**MIDVALE PLANNING AND ZONING COMMISSION  
SPECIAL MEETING  
AGENDA  
FEBRUARY 26, 2020**

2. CUP/SPR-22-30-128-035; 7200 SOUTH 300 EAST TOWNHOMES; 255-297 E FORT UNION BLVD; CONDITIONAL USE PERMIT AND PRELIMINARY SITE PLAN FOR 33-UNIT MULTIFAMILY RESIDENTIAL PROJECT; MIXED USE ZONE WITH 7200 SOUTH OVERLAY; ELGIN AVENUE HOLDINGS LLC (APPLICANT) (CONTINUED FROM 01-08-20)

<b>Planning and Zoning Commission Staff Report</b>
--

<b>APPLICATION:</b>	<b>IVORY INN – 33-UNIT MULTIFAMILY RESIDENTIAL PROJECT</b>
<b>LOCATION:</b>	255-297 E Fort Union Blvd
<b>APPLICANT:</b>	Quinn Millet, Elgin Avenue Holdings LLC
<b>FILE #:</b>	CUP/SPR – 22-30-128-035
<b>REQUEST:</b>	<b>CONDITIONAL USE PERMIT / PRELIMINARY SITE PLAN</b>
<b>MEETING DATE:</b>	February 12, 2020
<b>ZONING DESIGNATION:</b>	Mixed Use with 7200 South Overlay
<b>AUTHOR:</b>	Alex Murphy, Associate Planner
<b>APPLICABLE ORDINANCE(S):</b>	Midvale City Municipal Code Chapter 17-7-5 & 17-7-6
<b>AGENDA #:</b>	2

## SNOW REMOVAL PLAN

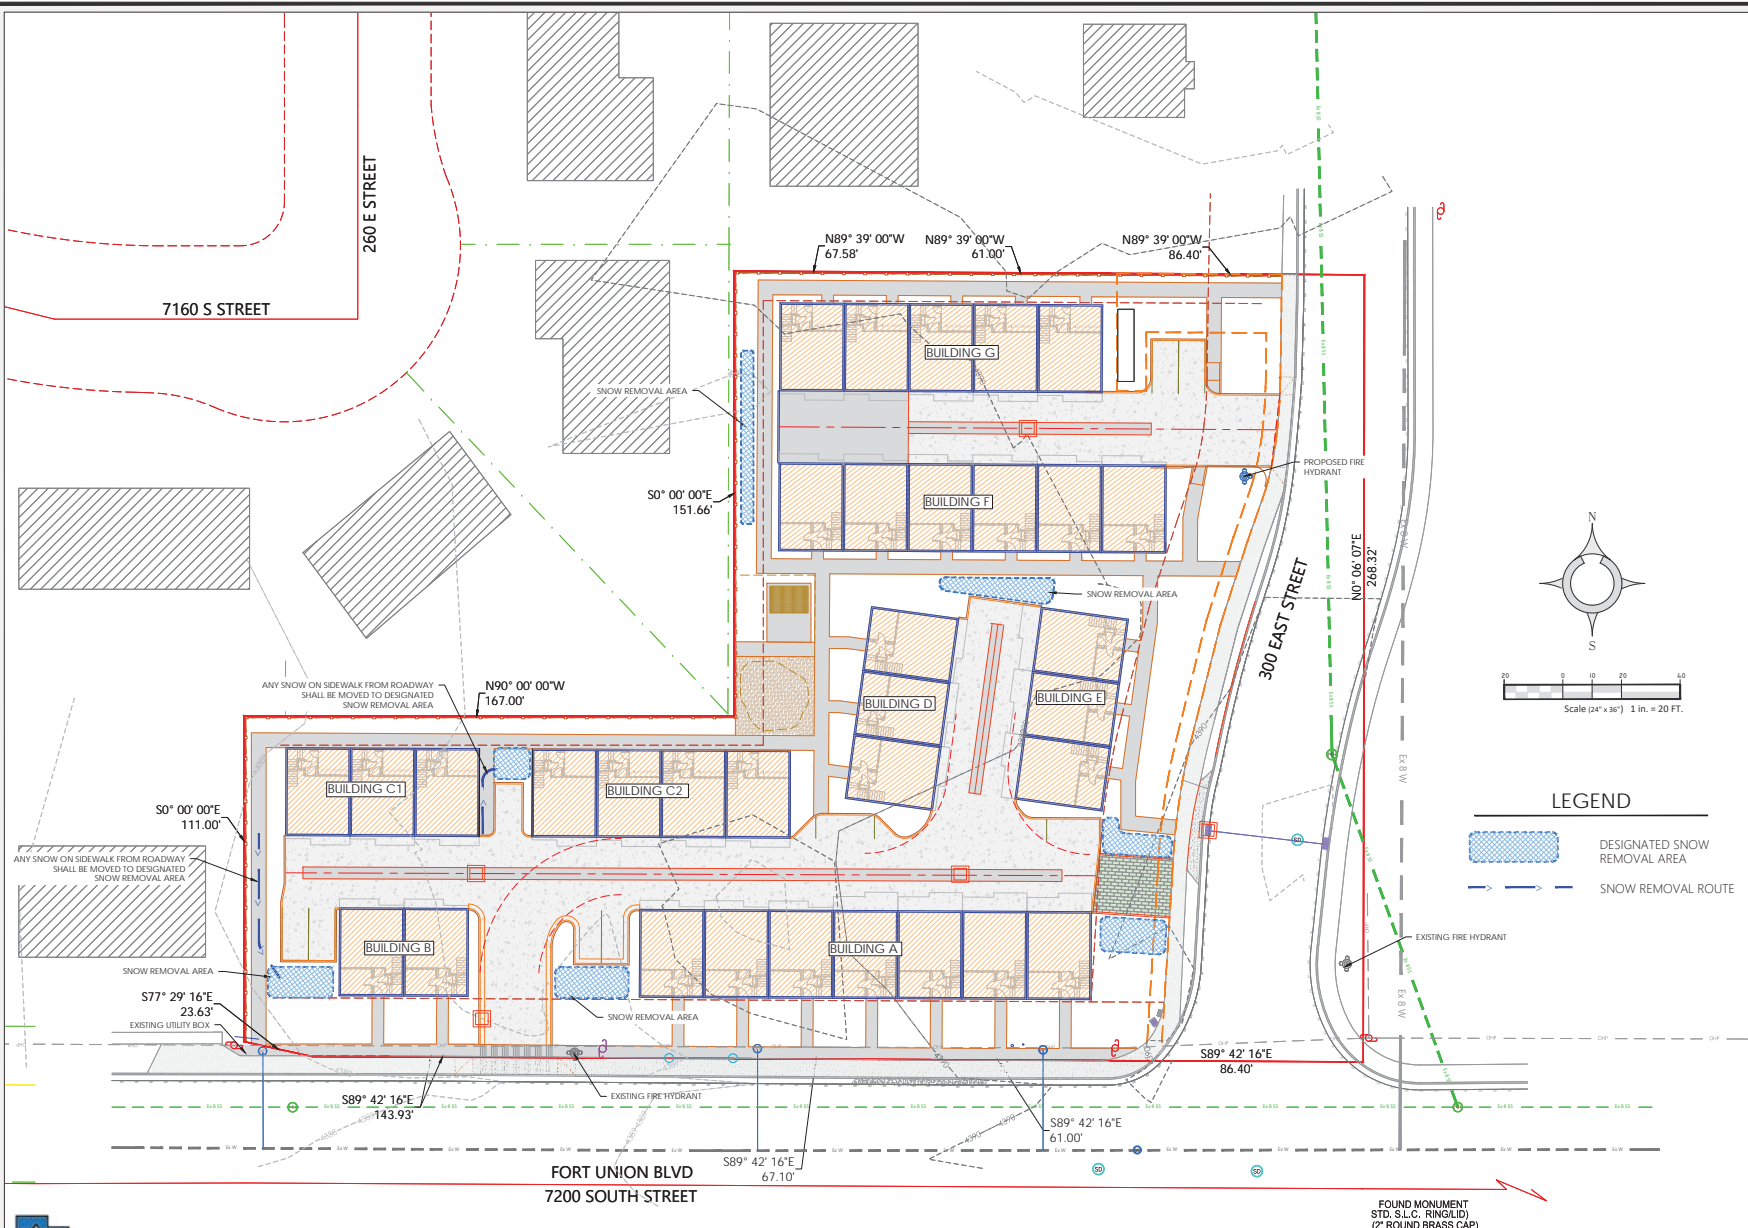
1. Revise the landscape design to meet the 40% open space requirement and
2. Revise the snow storage plan to remove conflicts with guest parking spaces.

The snow storage concerns have been addressed by revising the landscape plan. Areas where snow storage will occur have been modified from planter beds to turf, which will allow storage without negatively impacting trees or shrubs. Some of these snow storage areas overlap with the areas where Staff previously recommended removing turf, so that recommended condition has been removed.
